**TOWN AND COUNTRY PLANNING ACT 1990:  
SECTION 78 APPEAL**

**21-57 WILLOW WAY, LONDON, SE26 4AR**

PLANNING INSPECTORATE REFERENCE: APP/C5690/W/23/3321935  
LONDON BOROUGH OF LEWISHAM REFERENCE: DC/22/129789

**PROOF OF EVIDENCE**

**Figure 5-1: Proposed On-Street Servicing and Disabled Parking Provision**

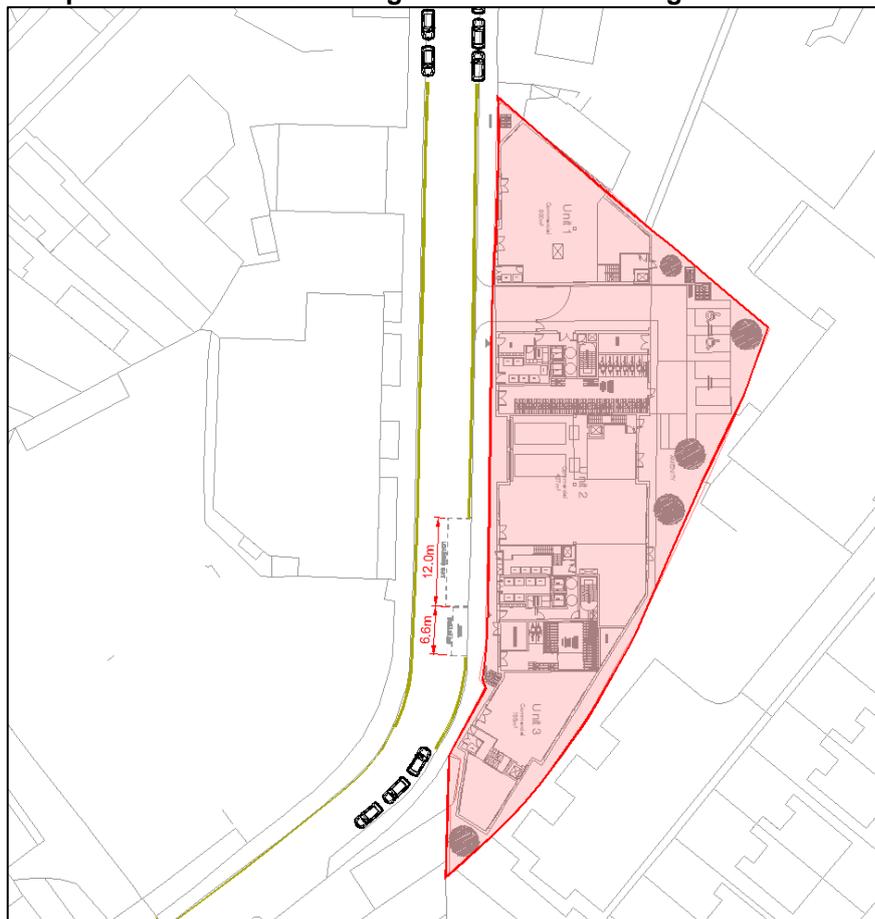
- 4.9 The provision of a single loading bay is acknowledged, but LBL consider that this should be provided at a length of 18m<sup>8</sup> to accommodate the potential worst-case demand of residential and commercial servicing vehicles.

- 5.3 VTP Drawing 4772-2001-T-002 Rev D, a copy of which is included within the Technical Note in Support of the Planning Appeal [CD-5.3.1] identified a single loading bay on the eastern side of Willow Way with a single on-street disabled parking bay provided to the immediate south of the proposed loading bay. **Figure 5-1** presents an extract of this provision.

- 5.4 The loading bay is identified as being 12.0m in length and the disabled parking bay is 6.6m in length. Whilst I appreciate that LBL consider that an 18.0m loading bay would accommodate the worst-case demand for use of this loading bay, it is unlikely that a large delivery vehicle of more than 10.0m in length would access Willow Way to service the existing or proposed uses within the wider Masterplan area. Even if a 12.0m rigid vehicle were to service the Site, which is generally considered to be the largest rigid vehicle that could access Willow Way, the identified loading bay width is considered to be of adequate length.

- 5.5 An 18.0m loading bay may be able to accommodate articulated vehicles, or more than 1 of the smaller rigid delivery vehicles at any one time. However, I do not consider that an articulated Heavy Goods Vehicle (HGV) would have any need to access Willow Way to service the existing or proposed units due to the nature and scale of these units. In addition, the original Transport Assessment [CD-1.16] identified that based on a generic assessment of the existing use of the Site, identified to be approx 1,341sqm of commercial floor space<sup>19</sup>, that a maximum of 1 HGV could access the existing use per hour<sup>20</sup>.

**Figure 5-2: Observed 7.5t Box Van on Willow Way**

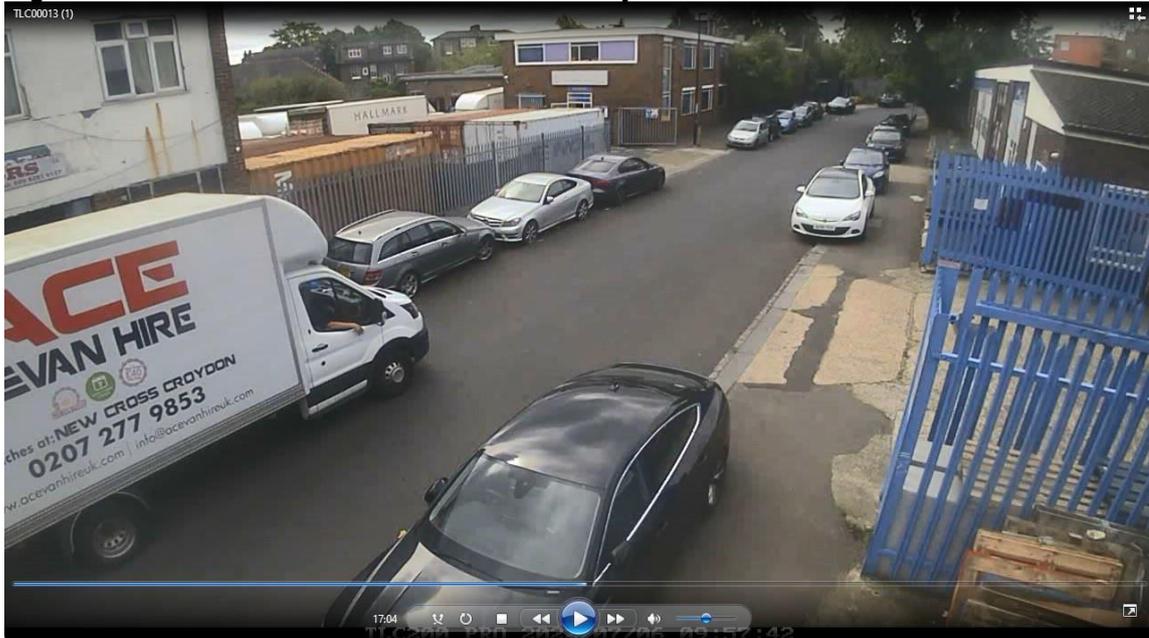
- 5.8 The analysis of the video survey undertaken on the 06<sup>th</sup> of July 2022, details of which are included within Appendix B of Technical Note in Support of the Planning Appeal [CD-5.3.1] identified that only LGV vehicles were observed servicing the existing units along Willow Way. **Figure 5-2** presents a screenshot of a 7.5t box van (LGV) stopped in Willow Way as an example of the types of vehicles that were observed along Willow Way.

**Figure 5-3: Proposed On-Street Servicing and Disabled Parking Provision**

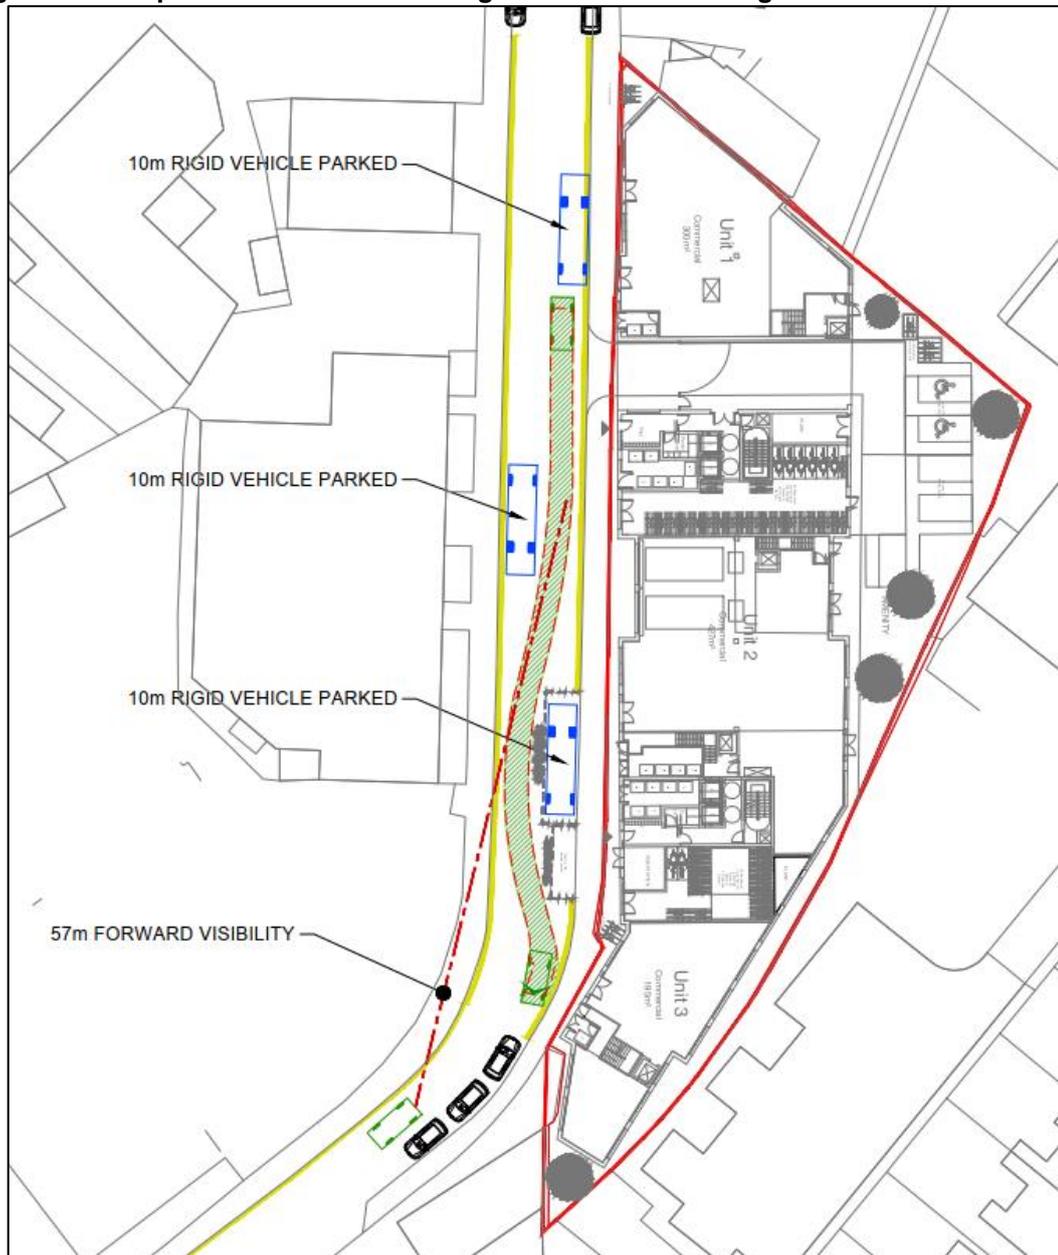
- 4.8 The continued servicing of existing businesses to the west of Willow Way should be clarified should the double yellow lines on both sides of Willow Way be introduced for the Plot A scheme.

- 4.13 In addition, the LBL Officer Report refers to the servicing arrangement for the existing uses to the west of Willow Way, and requested clarification on how this would continue should the introduction of the double yellow lines be approved for both sides of Willow Way<sup>13</sup>.

- 5.14 As set out within Appendix C of the Technical Note in Support of the Planning Appeal [CD-5.3.1], VTP Drawing 4772-2001-T-006 Rev B presents an arrangement whereby up to 3 large 10.0m rigid HGVs (considered to be the largest delivery vehicle that may be required to deliver to Willow Way) can all undertake deliveries simultaneously without hindering the operation of Willow Way.

- 5.15 It is acknowledged that at least two additional 10.0m rigid HGVs are shown to be stopped at convenient locations on either side of Willow Way where there are double yellow lines, i.e. not within the identified loading bay. However, in accordance with paragraph '5.18 – Loading Period' of the LBL Parking Policy (March 2023) document [CD-4.87], which it is acknowledged was updated on the 17<sup>th</sup> of April 2023, LBL have confirmed that LBL maintain the London Councils scheme of a 40-minute maximum period for loading or unloading along routes with single or double yellow lines<sup>26</sup>.

- 5.16 **Figure 5-3** presents an extract of the potential servicing arrangement in the interim phase of the Willow Way improvements, which would be associated with the Proposed Development of Plot A only. This was presented on VTP Drawing 4770-2001-T-006 Rev B, a copy of which is included within Appendix C of the Technical Note in Support of Planning Appeal [CD-5.3.1].

**Figure 5-5: Footway Clear Zone Design Standards**

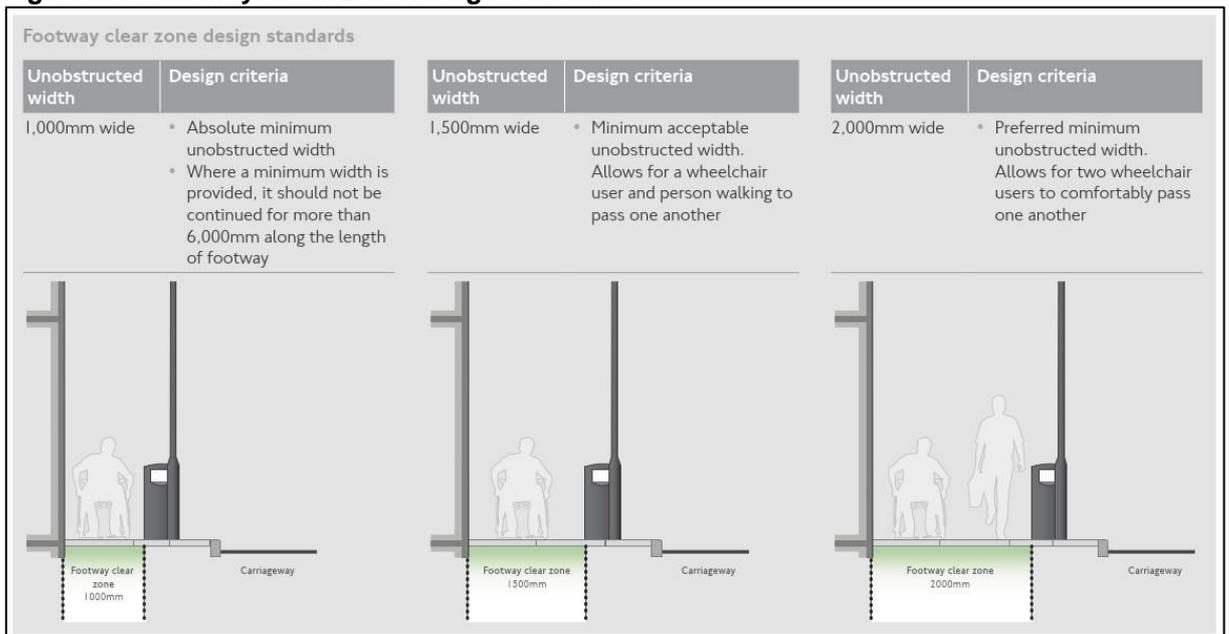
5.22 LBL have noted that the provision of a 1.2m footway adjacent to the vehicular access from Willow Way to the rear parking court of the Proposed Development, should be a minimum width of 1.5m in accordance with the TfL Streetscape Guidance [CD-4.88].

5.23 A review of the TfL Streetscape Guidance [CD-4.88] identifies that the design standards for footway clear zones would allow for an absolute minimum unobstructed width of 1,000mm to accommodate a wheelchair user<sup>29</sup> for a distance that should not exceed 6,000mm. I accept that the comment from LBL suggests that a 1,500mm provision would allow for a wheelchair user and a person to pass each other, but as noted within the VTP Technical Note in Support of the Appeal<sup>30</sup>, due to the exceptionally low number of potential wheelchair users (accounting for the disabled parking), and the low number of residential and employment trips that would access the site via this private footway, the level of conflict is not expected to be sufficiently high to require the additional provision.

5.24 In addition, there is scope to provide the dedicated footway at a level that is flush with the access road to the rear of the Proposed Development. Whilst only two disabled bays are proposed from the outset, with the potential to provide a further three disabled bays that could be accessed from the dedicated access arrangement, there would still be very few vehicle movements associated with the application site so as to accommodate a shared surface arrangement.
